Subject: Response to NRC Request for Additional Information (RAI) Regarding Materials Reliability Program (MRP)-169, "Technical Basis for Preemptive Weld Overlays for Alloy 82/182 Butt Welds in PWRs," Report (TAC NO. MD8005), April 07, 2008.

Project Number: 689

RESPONSES TO REQUEST FOR ADDITIONAL INFORMATION

Topical Report MRP-169 "Technical Basis for Preemptive Weld Overlays for Alloy
82/182 Butt Welds in PWRs"

Figure A-1 – Post-Overlay Axial Residual Stress Comparison (Surge Nozzle vs. PWOL Mockup) at 70°F

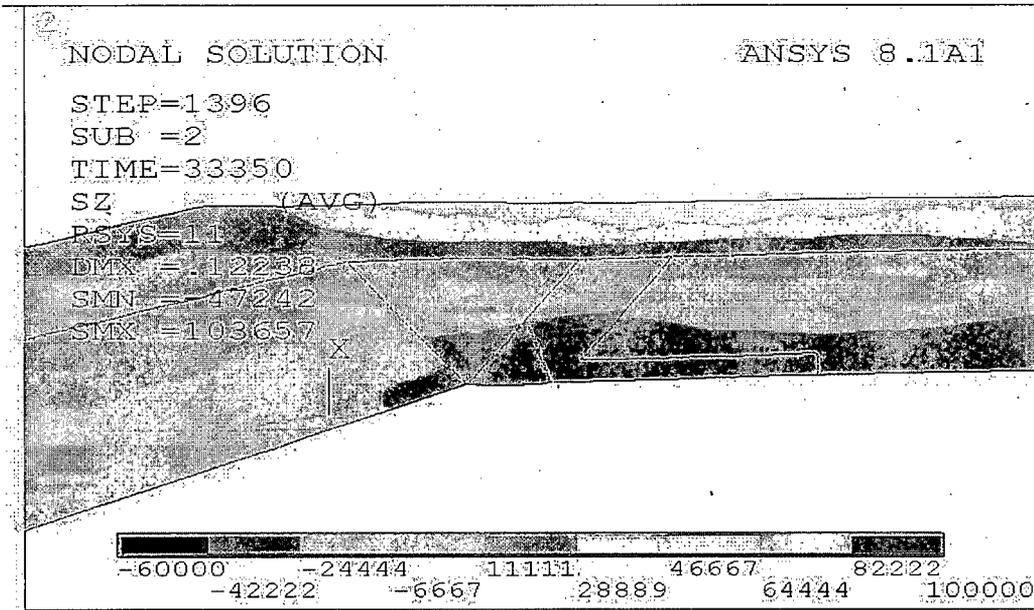
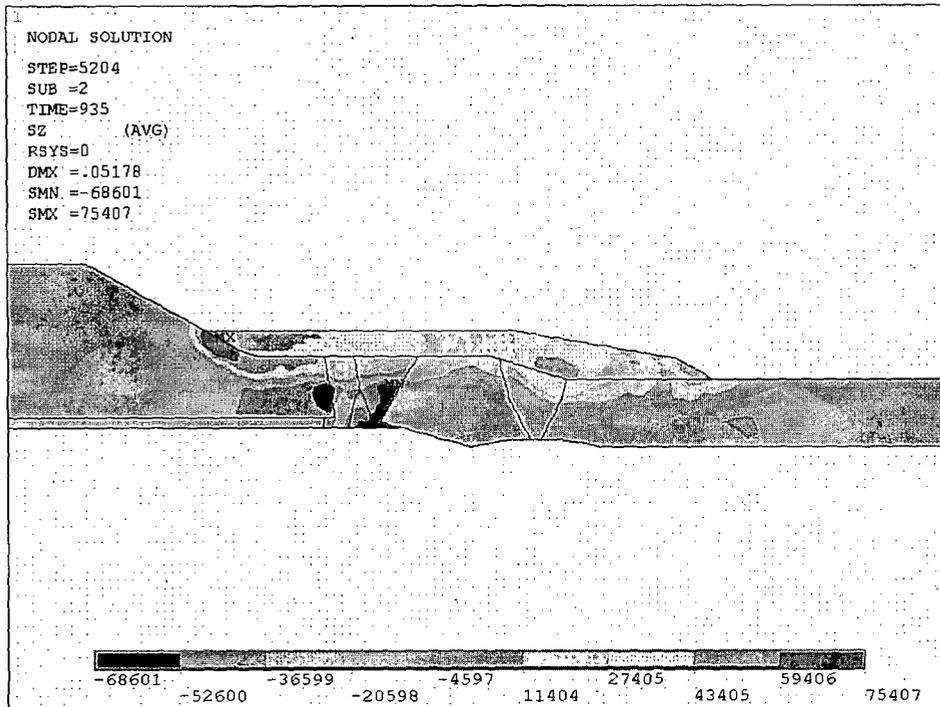
Question 23: Figures A-1 and A-2 on pages 25 and 26 appear to have an editorial error. Based on the SY and SZ notation, it appears that Figure A-1 compares the hoop stress of the Surge Nozzle Example and the axial stress of PWOL Mockup. A similar error appears to have been made on Figure A-2. Please explain the discrepancy.

Appendix A to this response provides contour plots of axial and hoop post-overlay residual stresses at 70°F for the surge nozzle example of Section 8 and the PWOL mockup of Section 5. Careful examination of these plots indicates that the residual stress distributions for the two are quite similar, when compared under like conditions.

Proposed Response: There is no error in Figures A-1 and A-2 of the prior RAI response. The mockup stress contour plots are presented in a local coordinate system, rather than the global coordinate system indicated on the figures.
